SERVICE INFORMATION

APPLICABILITY: 2010-14MY Legacy and Outback **NUMBER:** 12-178-15
SUBJECT: Hood Latch and Striker Mounting Bolt Change **DATE:** 01-30-15

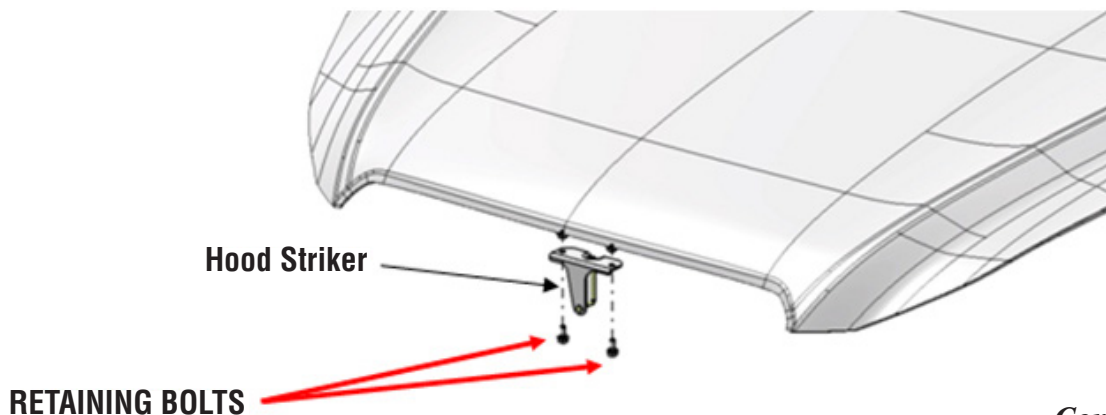
This Service Information bulletin announces a change to the appearance of the hood latch and striker mounting bolts. The original bolts had a black-colored finish while the new bolts are silver in color. There is no change to the shape or strength of the bolts.

The new silver-colored bolts were incorporated into production during February, 2014 starting with the following VINS:

- Legacy: **E*029476**
- Outback: **E*293637**

Bolt Color **BLACK** p.n. **901000332**

Bolt Color **SILVER** p.n. **901000407**

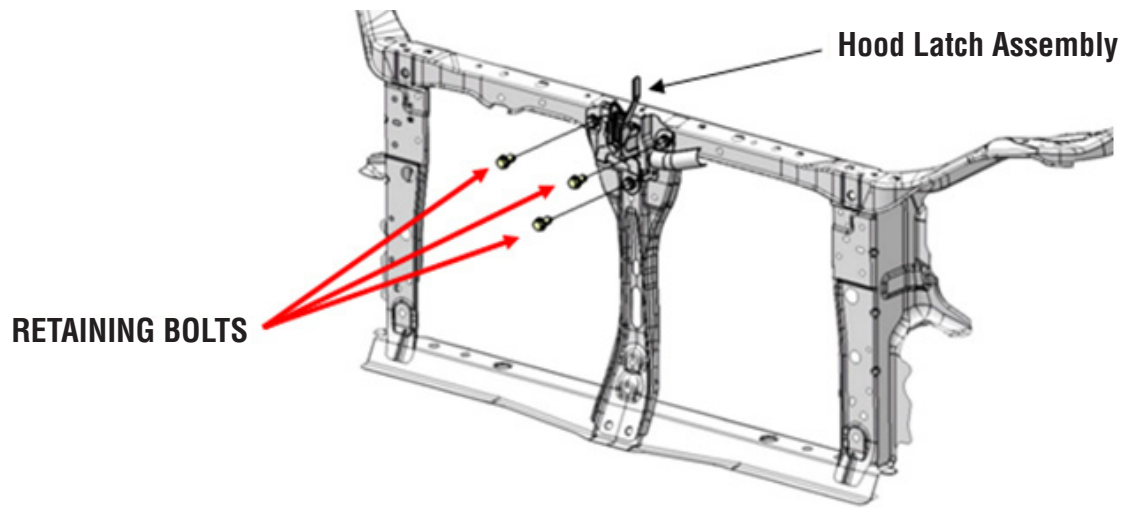
- When replacing any of these bolts, replace with the same part number as originally installed.
- The hood latch and striker bolts are the same. Do not mix new and old on the same vehicle.

The torque specifications are also unchanged:

- Hood Latch bolts (3): torque to 24.3 ft. lbs
- Hood Striker bolts (2): torque to 18.4 ft. lbs.
